Docket No. 50-447

SUBJECT: 01 FOR GESSAR PRA REVIEW

AEB QUESTIONS ON GESSAR PRA

FIGURE (1) SEARC-R VS. EPRI AND VNC DATA

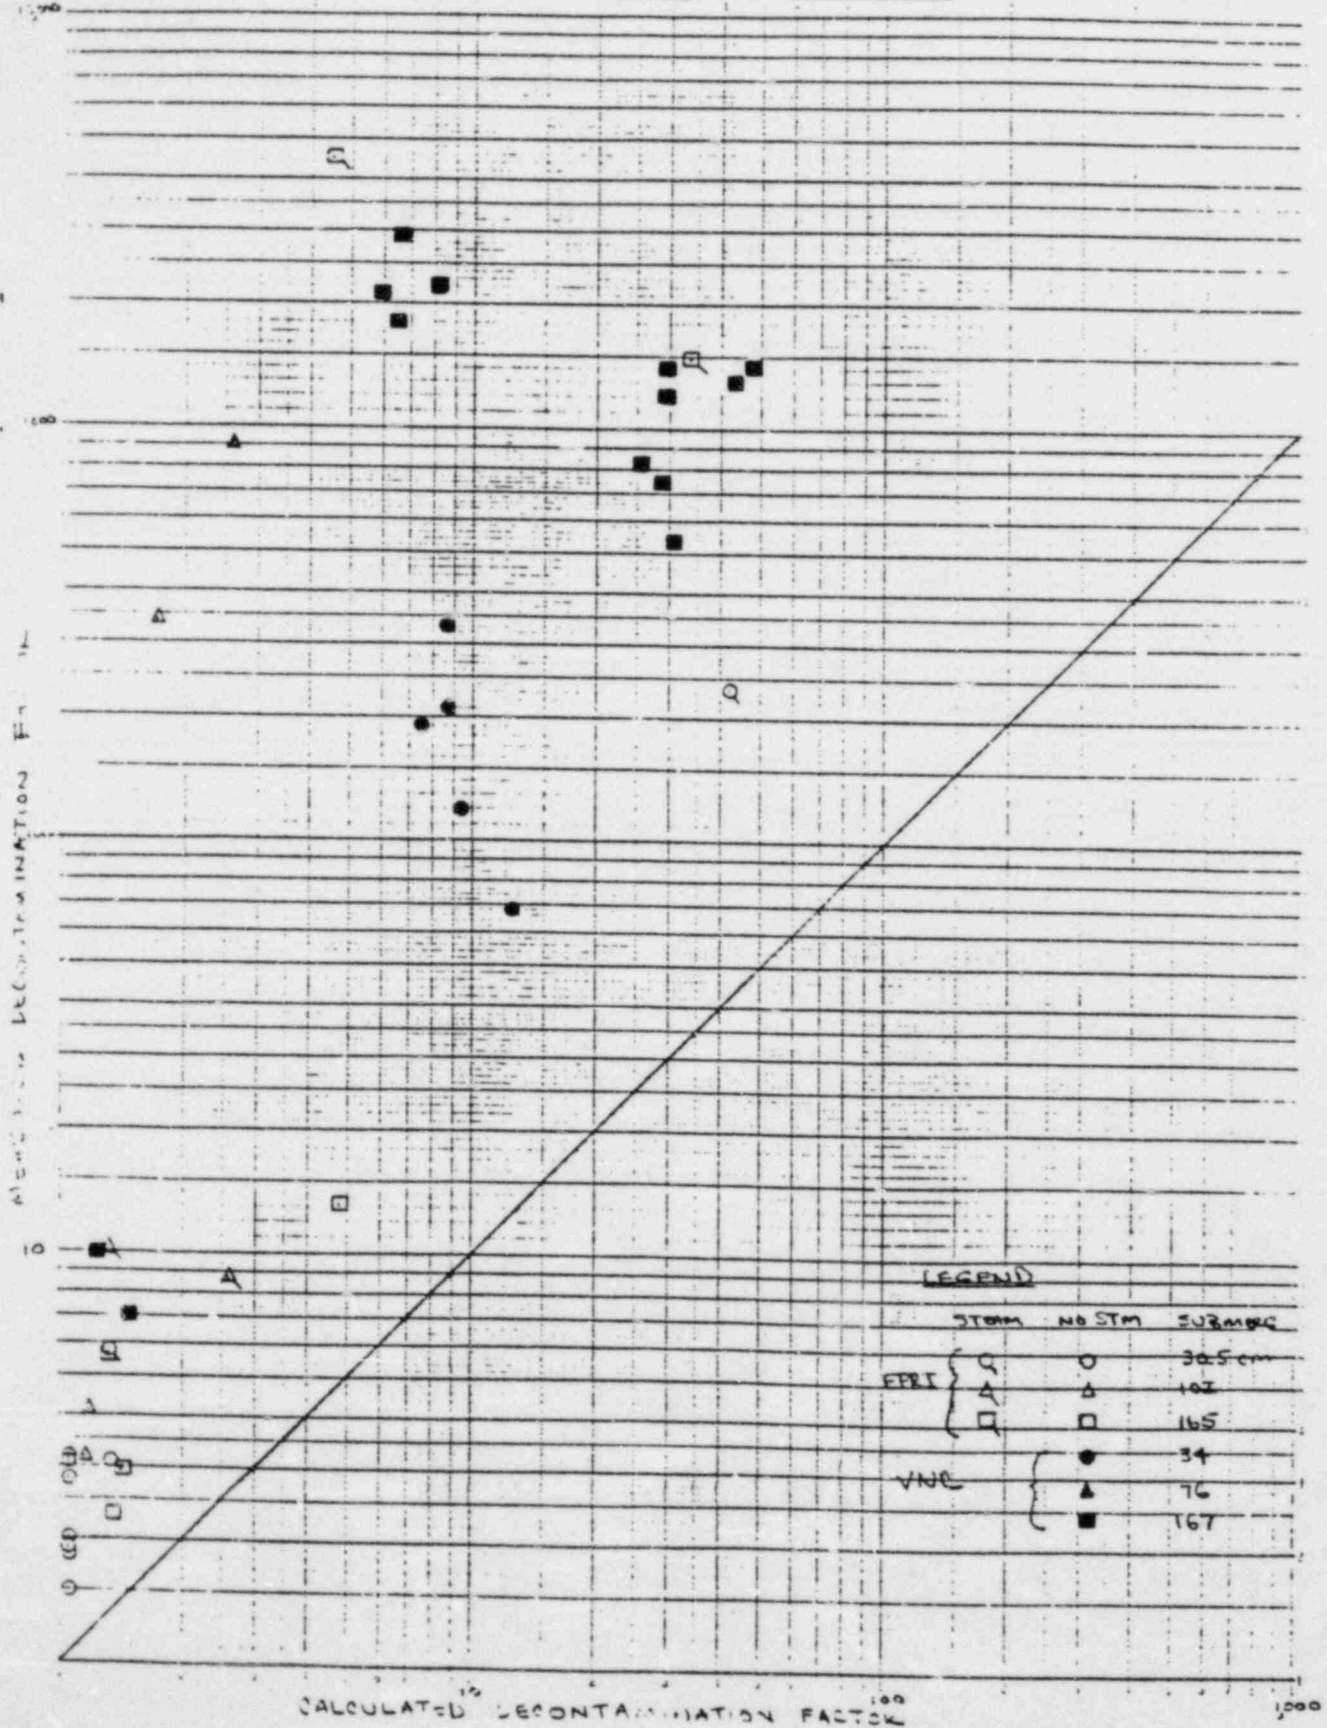
- 1. SPARC-B Underpredicts Most Data
 - Large Deviation At Low DF and Low Submergence (Entrance Effect Dominant)
 - Data Is For A Range Of Rise Velocities
 - SPARC-B Rise Velocity Is Greater Than Actual Velocities
 - Predictions Will Improve With Actual Velocity

SPARC B + ENTRANCE B VS EPRI AND VNC DATA

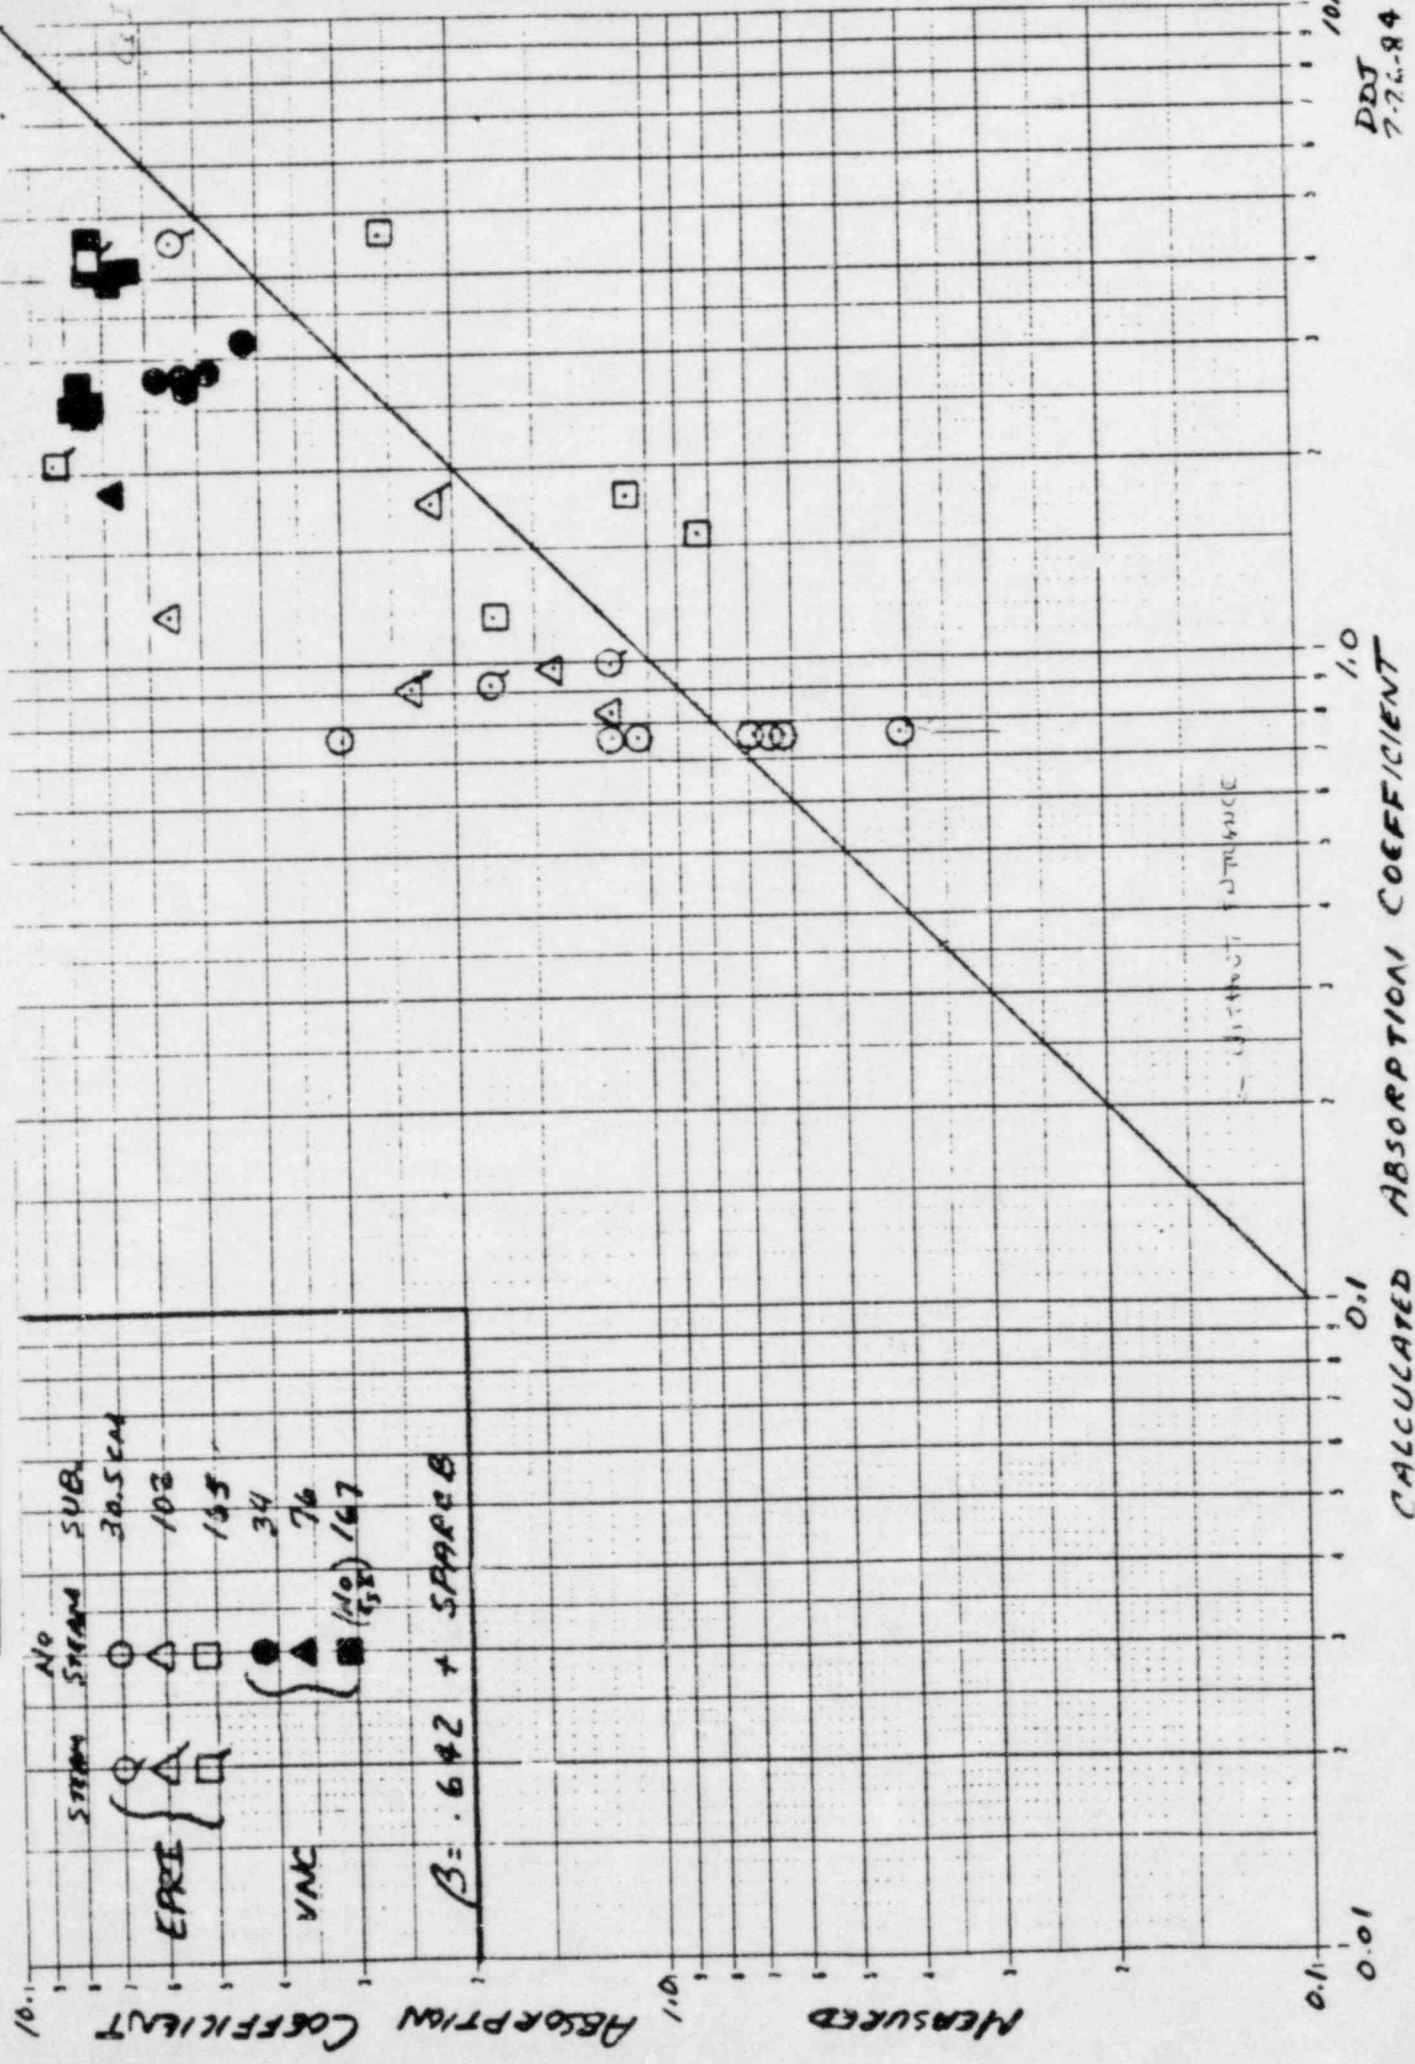
- 2. SPARC-B WITH ENTRANCE DF

- Entrance DF ~ 1.9 ($\ln DF = .64$)
 - Large Improvement
 - Absorption Coefficient Within 1 Order of Magnitude

SPARCB + ENTRANCE β + TESTED VELOCITY VS. EPR1 AND VNC DATA

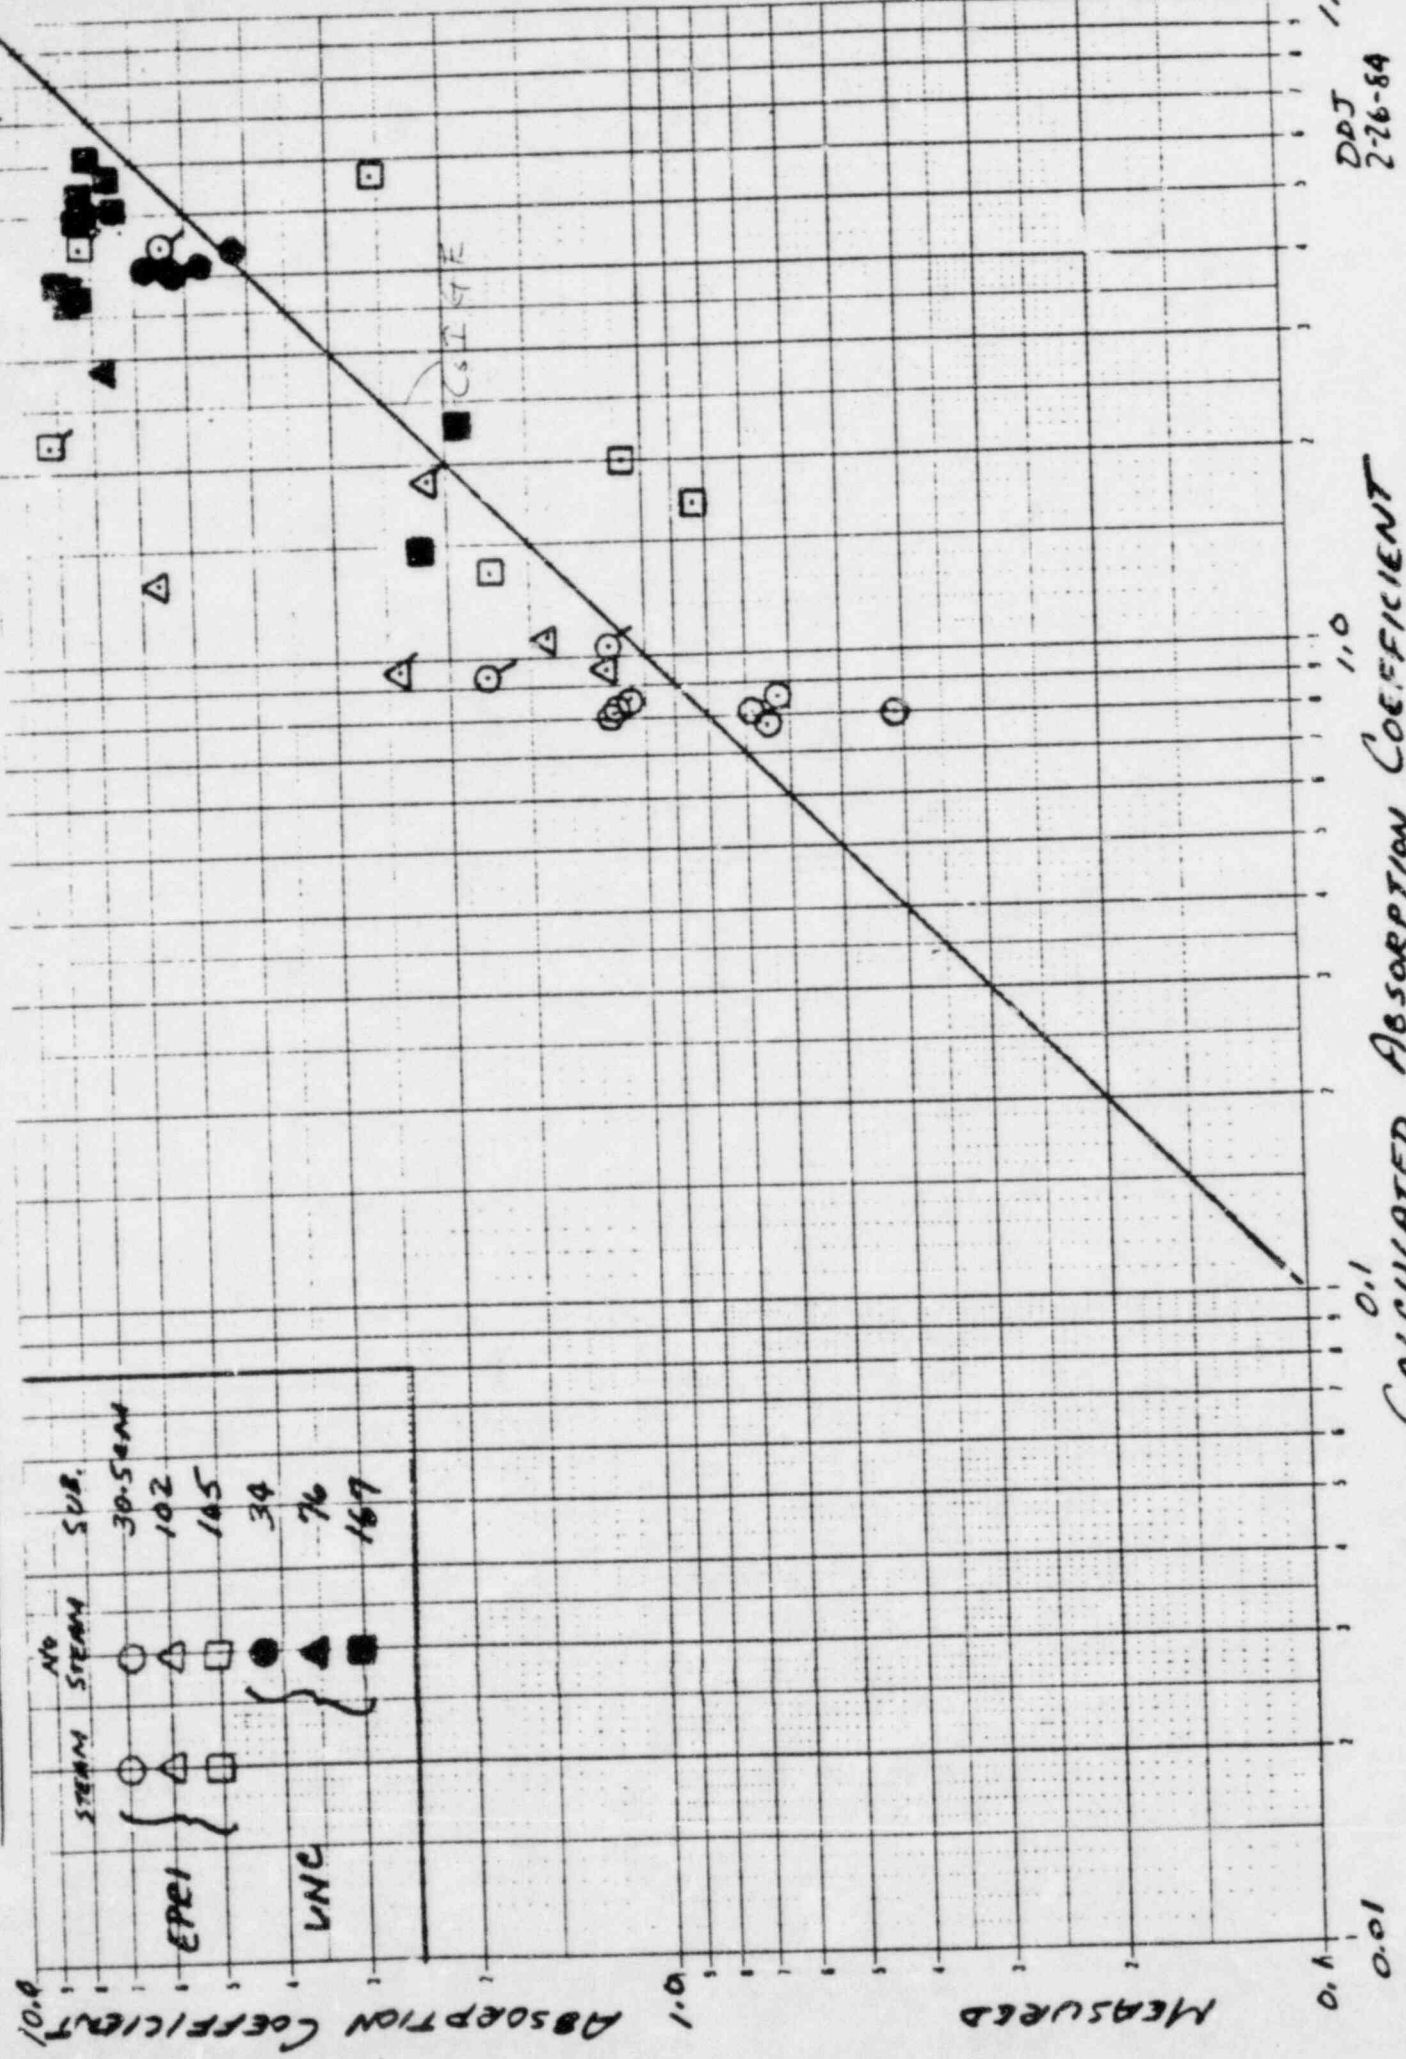
- 3. SPARC-B WITH ENTRANCE DF + ACTUAL VELOCITY

- Small Improvement For EPRI Data, But Important To Use Actual Velocity
 - Effect Is Small Due To Low Submergence In EPRI Data
 - Comparison With Data Generally Much Better, But Calculated DFs Are Still Low
